STREET LIGHTING PLANS

FED. RD. DIV. NO.	PROJECT NO.		SHEET NO.	
6	(See Title Sheet)		836	
STATE	STATE DIST. NO.	COUNTY		
TEXAS	18	ROCKWALL		
CONTROL	SECTION	JOB	HIGHWAY NO.	
0451	01	032	SH 205

56 Change Order

FED. RD. DIV. NO.	PROJECT NO.		SHEET NO.
6	See Title Sheet		842A
STATE	STATE DIST. NO.	COUNTY	
TEXAS	18	ROCKWALL	
CONTROL	SECTION	JOB	HIGHWAY NO.
0451	01	032	SH 205

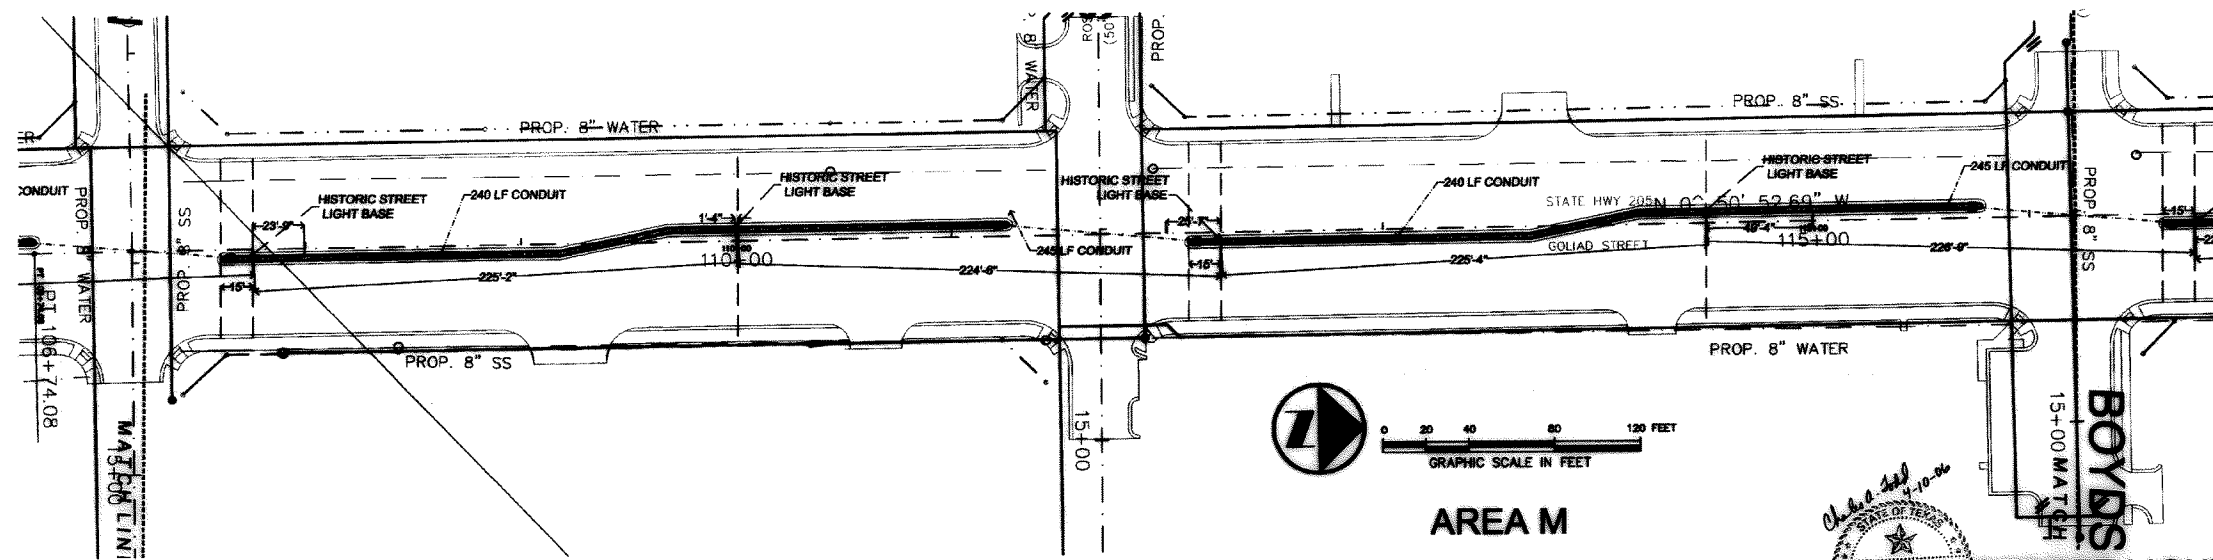
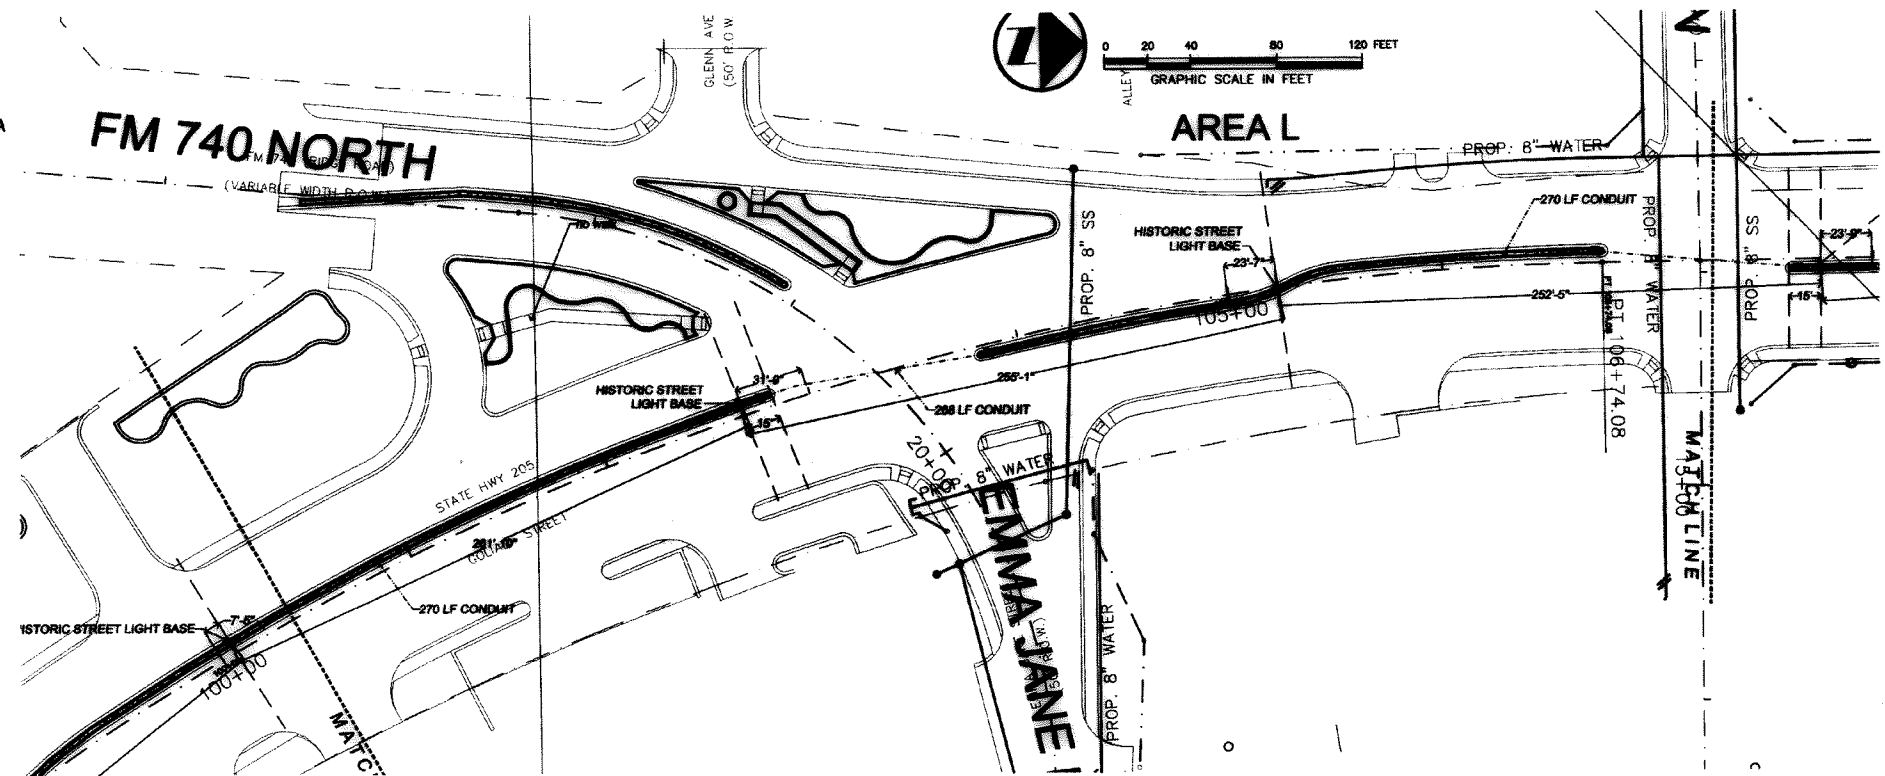
1. FIELD ADJUST LIGHT BASE LOCATIONS TO WORK AROUND EXIST. UTILITIES.

AREA N

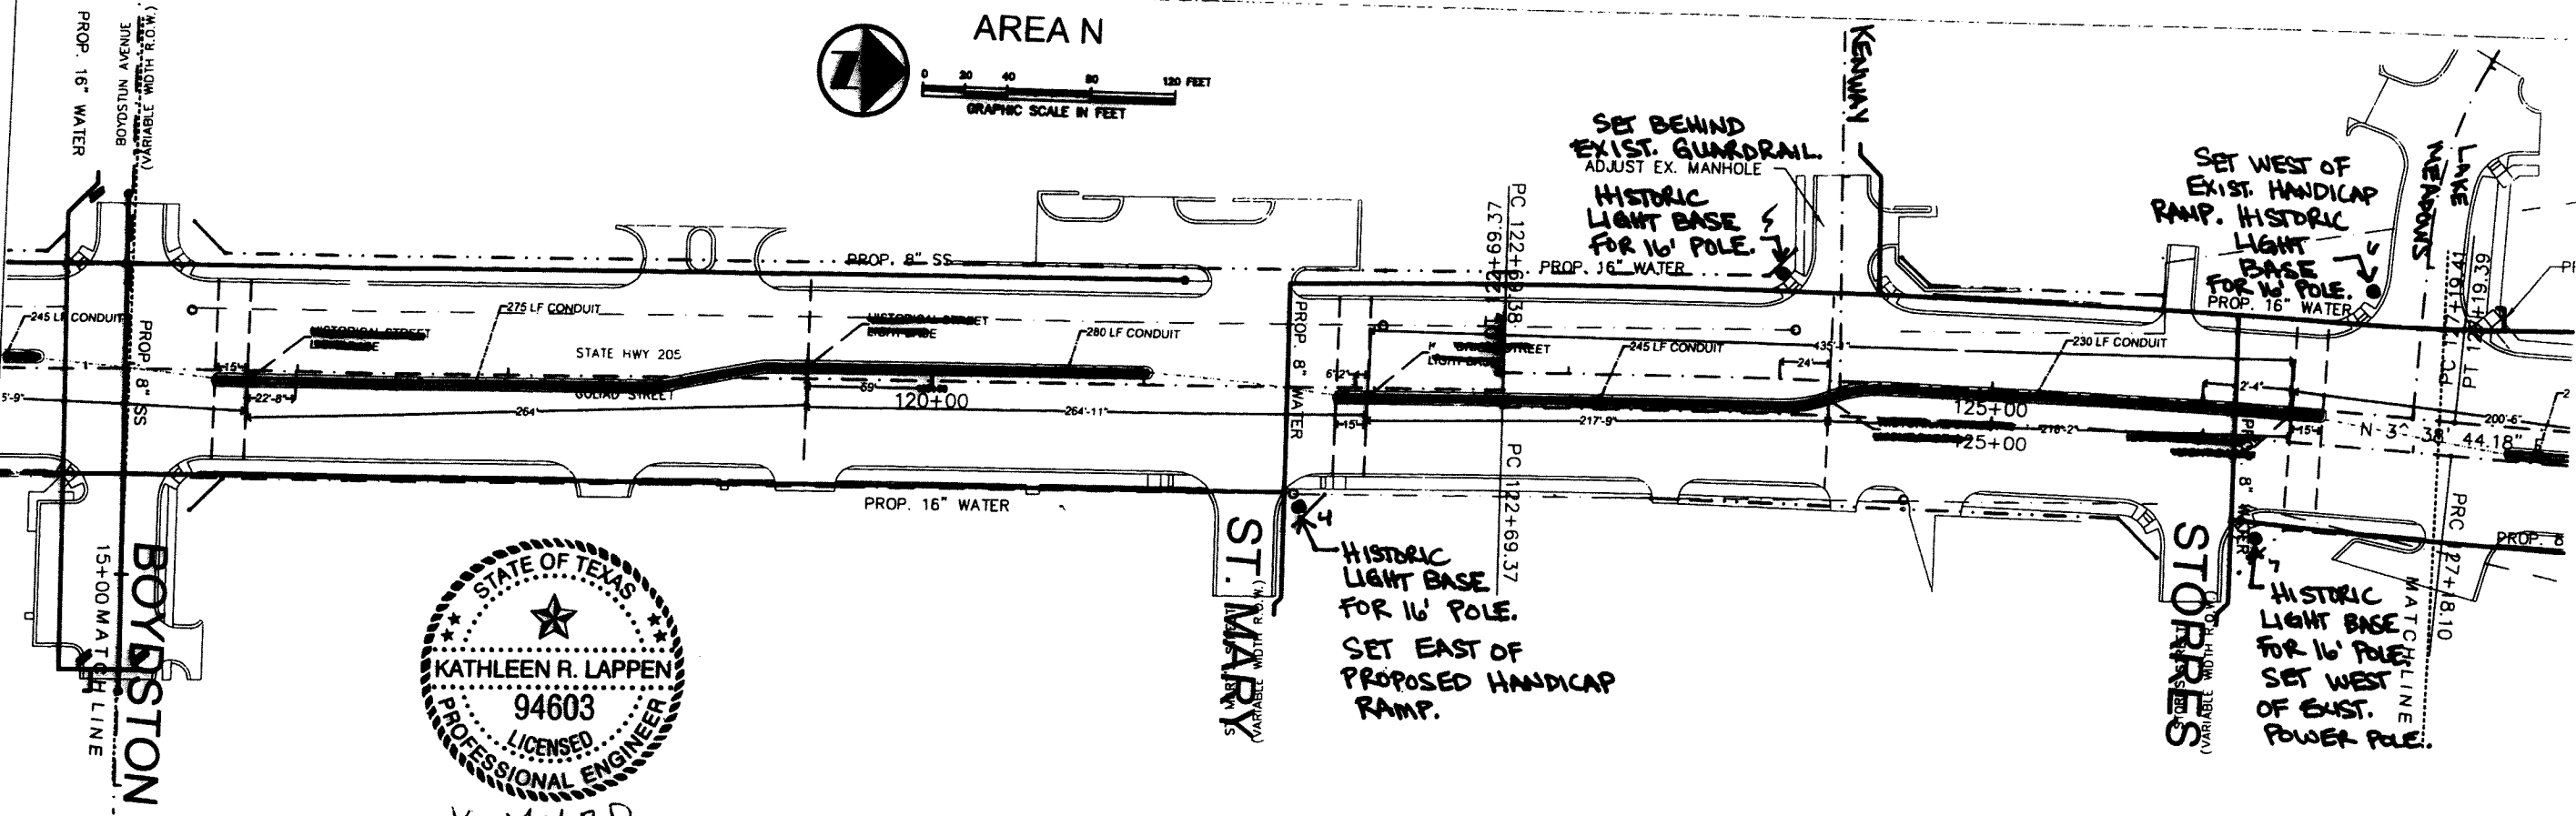
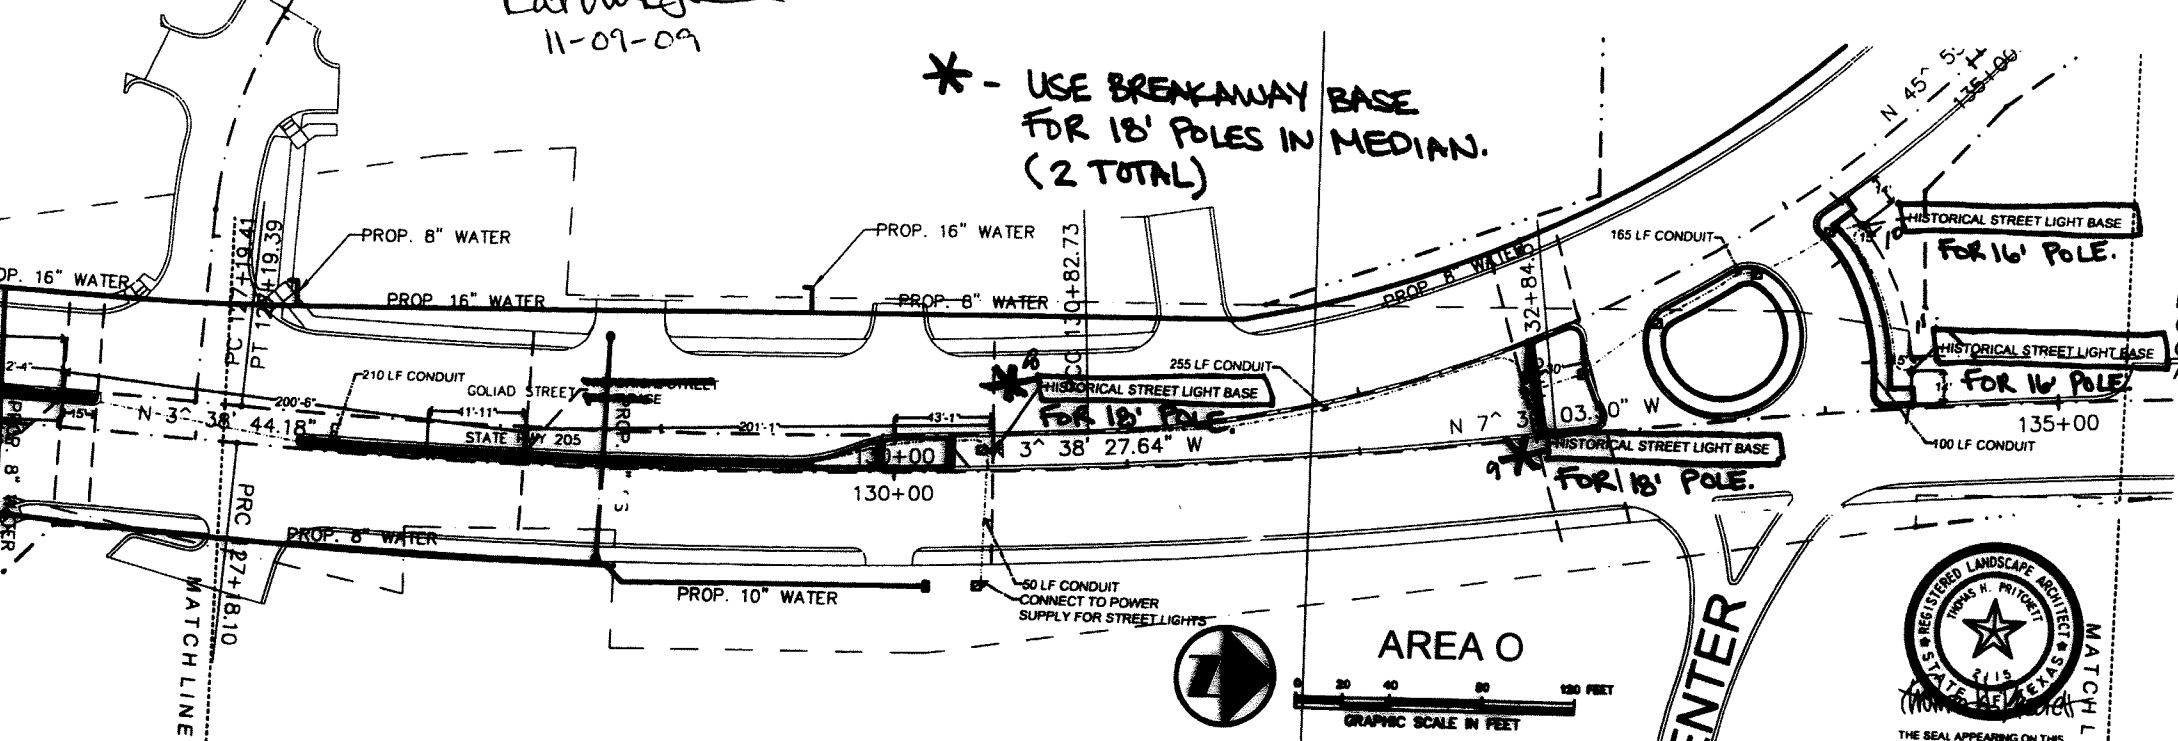
*** - USE BREAKAWAY BASE FOR 18' POLES IN MEDIAN. (2 TOTAL)**

ANCHOR BOLT DETAIL

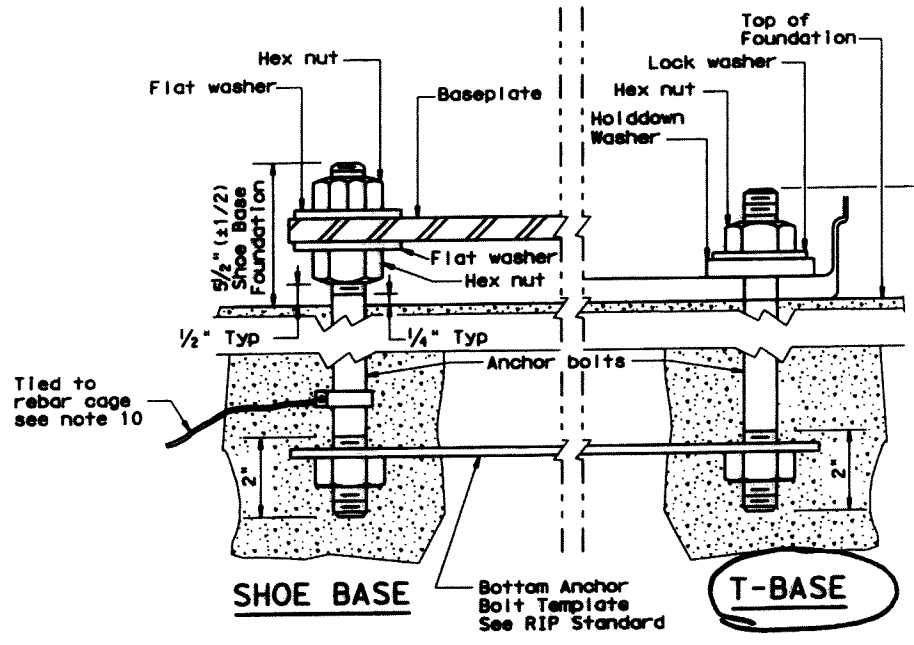
FOR BREAKAWAY BASE:

- Change length and have 4" bend
- Use bolt pattern supplied by manufacturer.
